COMMENT SET 9: COMMUNITIES FOR A BETTER ENVIRONMENT

RE: Comments on the Tesoro Avon Marine Oil Terminal Lease Consideration Project

Communities for a Better Environment (“CBE”) and the Center for Biological Diversity (“Center”) offer the following comment on the Draft Environmental Impact Report (“DEIR”) for the Tesoro Avon Marine Oil Terminal Lease Consideration Project (“Project”). This Project is not a “business as usual” lease renewal. In fact, the Project’s true objective is to enable Tesoro to receive increased shipments of lower quality, more volatile and polluting oil feedstock. This would cause far more significant impacts than disclosed in the DEIR. The DEIR obscures this reality, thereby failing as an informational document under the California Environmental Quality Act (“CEQA”).

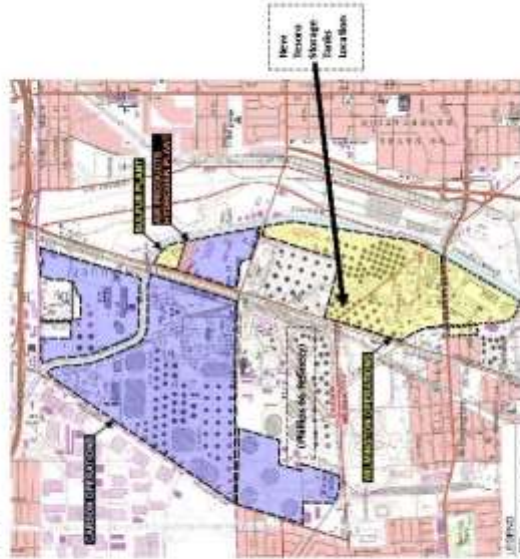
If light, low sulfur Alaska North Slope (ANS) crude oil, which is continually lowering in production, is displaced with extremely heavy, high sulfur Canadian tar sands crude oil, clearly that would increase sulfur content in the refinery, increase corrosion hazard and potential impacts of H2S gas, and require additional energy to process the heavy crude.

If Bakken crude oil were to replace, for example, ANS at the Tesoro refineries, this may or may not be comparable to ANS crude in gravity and sulfur content, (since Bakken is acknowledged as extremely variable). However, even if the Bakken crude were light, its high paraffin content described above, can cause waxy, dangerous buildup in transport, in the refineries, can be accompanied by toxic diluents, and explosion hazards (a La Lac Megantic explosion in Canada).

If Bakken is mixed with heavy crudes, asphaltene destabilization, preheater fouling, desalter upsets, unwanted coking, etc., identified earlier in the Hydrocarbon Processing article, can occur. These impacts can cause dangerous shutdowns and accidents. The specific changes must be identified to provide an accurate Project Description, to enable a full evaluation of potential impacts.

If instead, which may be the most likely case, heavy Canadian Sablet would replace California heavy crude at the Wilmington facility, then sulfur content and API gravity goes up considerably, causing increased presence of H2S and increased energy use; while the Bakken imports would go to the Carson portion of the refinery complex, which is designed to handle lighter crude, but introducing the documented problems associated with Bakken characteristics that are not present in, for example, Alaskan crude.

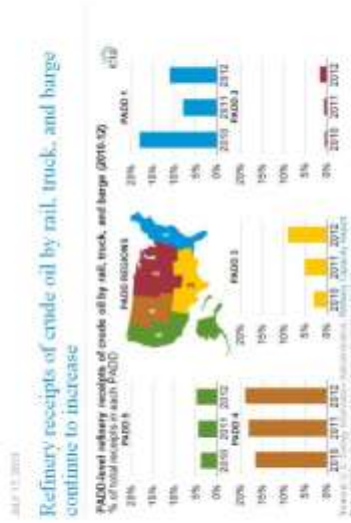
I have circled the end of the pipeline route which was identified in the refinery layout map provided by the ND. The ND graphic shows an additional length of pipeline beyond the Project tanks to the corner of the Wilmington refinery property, but provides no explanation about the potential for this extended pipeline to connect with additional refinery and logistics operations (including the Carson refinery, the adjacent rail yard, other storage tanks, and potentially even to trucking assets). There is also an extra leg of pipeline indicated without explanation, between two tanks that were not identified as part of the Project.

The ND must be reevaluated as a full EIR, and the potential for connections to the Carson portion of the refinery must be identified. Existing nearby pipelines and connections, plans made known to the AQMD, of such connections, and the general potential for such connections that the Project facilitates must be evaluated.
